# Access Compliance Report

## Public Rights-of-Way

### (Curb Ramps)

Intersection ID: 31922	Main Street: RIM_ROCK_CT	Cross Street: STOWE_DERBY_DR	Location: NW
ADA ID: 4533730061E5	Ramp Type: PerpDiag	Initial Pass/Fail: Fail	Overall Compliance: No
Severity Score: 46.25			
Codes/Mitigation Info/Possible Solution		Field Measurements/Component Compliance

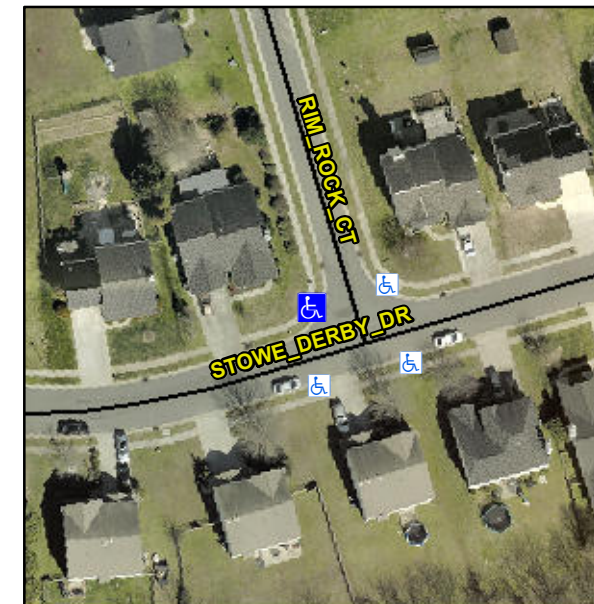
**R304.5.1, R304.2.2, R304.5.3**

Compliance	Description	Data	Compliance	Description	Data
N/A	Ramp Length (in)	47.5	No	Ramp Slope (%)	9.3
No	Ramp Width (in)	47.0	No	Ramp XSlope (%)	7.1
N/A	Flare Type LT	N/A	N/A	Flare Type RT	N/A
N/A	Flare Slope LT (%)	N/A	N/A	Flare Slope RT (%)	N/A
N/A	Flare Traversable LT?	N/A	N/A	Flare Traversable RT?	N/A
N/A	Landing Length (in)	N/A	N/A	DWS Provided?	N/A
N/A	Landing Width (in)	N/A	N/A	DWS Contrast?	N/A
N/A	Landing Slope (%)	N/A	N/A	DWS Length (in)	N/A
N/A	Landing X Slope (%)	N/A	N/A	DWS Full Width?	N/A
N/A	Landing Curb? (Y/N)	N/A	N/A	DWS Offset (in)	N/A
N/A	Shared Landing?	N/A			
N/A	Gutter Ponding?	N/A	N/A	Gutter Slope (%)	N/A
N/A	Gutter Lip Ht (in)	N/A	N/A	Gutter X Slope (%)	N/A
N/A	Painted X Walk1?	No	N/A	Painted X Walk2?	No
	X Walk 1 Direction	To S		X Walk 2 Direction	To E
N/A	X Walk 1 Width (in)	N/A	N/A	X Walk 2 Width (in)	N/A
	X Walk 1 Slope (%)	4.2		X Walk 2 Slope (%)	2.9
	X Walk 1 X Slope (%)	3.3		X Walk 2 X Slope (%)	4.6

**Remove & Replace Curb Ramp With Two New Directional Ramps or Equivalent.**
